Access Compliance Report

Public Rights-of-Way

Intersection ID: 44922	Main Street: MAPLE_PARK_LN	Cross Street: ROBUR_CT	Location:	E
ADA ID: E3659151DAC1	Ramp Type: Perp	Initial Pass/Fail: Fail	Overall Compliance: No	Severity Score: 12.5

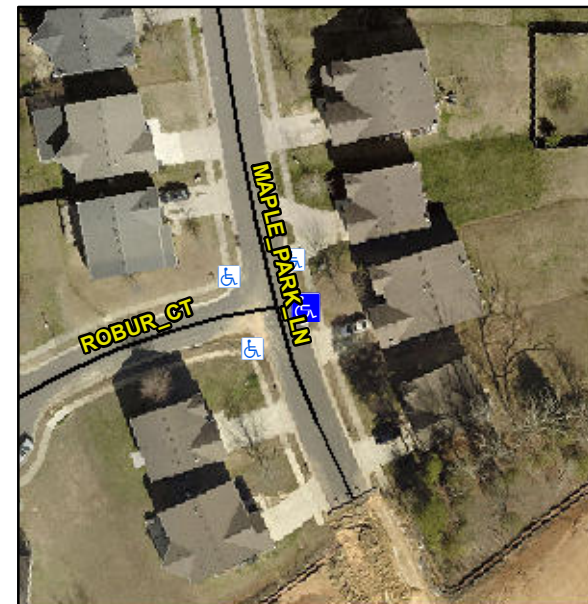
Not Found, R304.2.2

Compliance	Description	Data	Compliance	Description	Data
N/A	Ramp Length (in)	49.0	No	Ramp Slope (%)	11.5
Yes	Ramp Width (in)	48.0	Yes	Ramp XSlope (%)	1.4
N/A	Flare Type LT	N/A	N/A	Flare Type RT	N/A
N/A	Flare Slope LT (%)	N/A	N/A	Flare Slope RT (%)	N/A
N/A	Flare Traversable LT?	N/A	N/A	Flare Traversable RT?	N/A
N/A	Landing Length (in)	N/A	N/A	DWS Provided?	N/A
N/A	Landing Width (in)	N/A	N/A	DWS Contrast?	N/A
N/A	Landing Slope (%)	N/A	N/A	DWS Length (in)	N/A
N/A	Landing X Slope (%)	N/A	N/A	DWS Full Width?	N/A
N/A	Landing Curb? (Y/N)	N/A	N/A	DWS Offset (in)	N/A
N/A	Shared Landing?	N/A			
N/A	Gutter Ponding?	N/A	N/A	Gutter Slope (%)	N/A
N/A	Gutter Lip Ht (in)	N/A	N/A	Gutter X Slope (%)	N/A
N/A	Painted X Walk1?	No	N/A	Painted X Walk2?	N/A
	X Walk 1 Direction	To W		X Walk 2 Direction	N/A
N/A	X Walk 1 Width (in)	N/A	N/A	X Walk 2 Width (in)	N/A
	X Walk 1 Slope (%)	3.7		X Walk 2 Slope (%)	N/A
	X Walk 1 X Slope (%)	2.3		X Walk 2 X Slope (%)	N/A

Remove & Replace Entire Ramp.
